Item 3.**Section 8.2 Review of Determination: 212-214 King Street, Newtown - RD/2025/585/B****File Number:** RD/2025/585/B**Summary****Date of Lodgement:** 21 January 2025**Application Type:** Division 8.2 review application**Date of original determination:** 15 October 2025**Required determination date:** 15 April 2026**Applicant:** SLR Consulting**Architect/Designer:** Richmond + Ross Consulting**Developer:** McDonald's Australia**Planning Consultant:** SLR Consulting**Heritage Consultant:** NRBS & Partners Pty Ltd**Cost of Works:** \$1,751,791.00**Zoning:** E1 Local Centre**Proposal Summary:** A request for a review of the determination of the development application D/2025/585 under the provisions of Section 8.2(1)(a) of the Environmental Planning and Assessment Act (EP&A Act) has been submitted.

Figure 5: Proposed ground floor plan

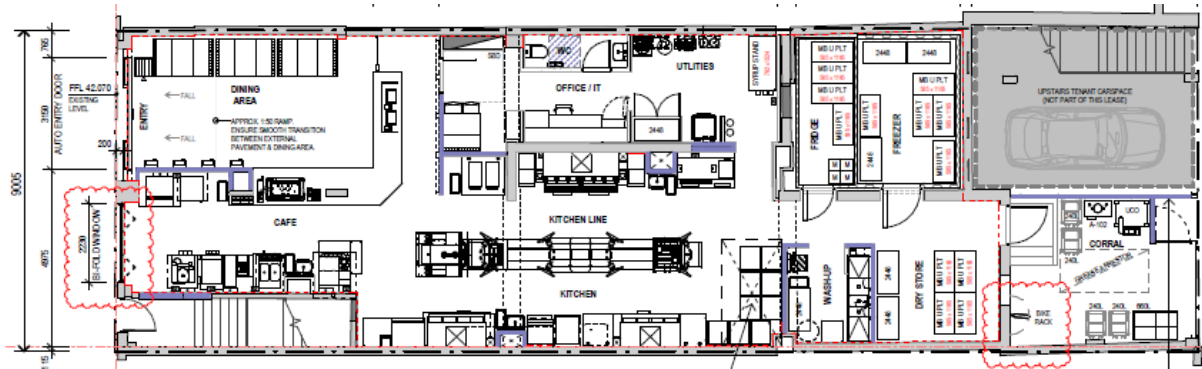
- (b) lack of on-site bicycle parking spaces for delivery riders and staff
32. This review application does not change the internal layout as proposed under the original development application, except for the inclusion of one onsite staff bicycle parking space. Importantly, the review application does not provide an onsite loading area or visitor bicycle parking area.

33. The proposed floor plan shows an indoor dining area with booth seating for approximately 12 persons, and the rest of the floor area being a large kitchen and back of house (approximately 225 sqm or 90% of the premise's floor area). The predominant service kitchen and food preparation areas compared to the dining area signifies that the majority of food and drink will be consumed away from the site.

39. Currently the site offers 2 rear parking spaces for the ground floor tenant, which could be utilised for servicing and loading for the proposed takeaway premises. However these 2 parking spaces are to be removed and converted into internal waste management and storage area.

48. The current waste storage room design and waste collection arrangement do not comply with the following requirements under the City's Guidelines for waste management in new developments ('waste requirements'):

- (d) The proposal lacks details to provide waste storage area with 1.5m wide aisle for bin manoeuvring, 10cm gap between all bins, and bins to be stored no more than 2m deep.

- (e) Any doorways, corridors, and gates used to transport bins must have a minimum clear width of 1800 mm to allow for the passage of large bins and staff. However, the proposal provides a waste access door that is significantly narrower than 1800 mm.
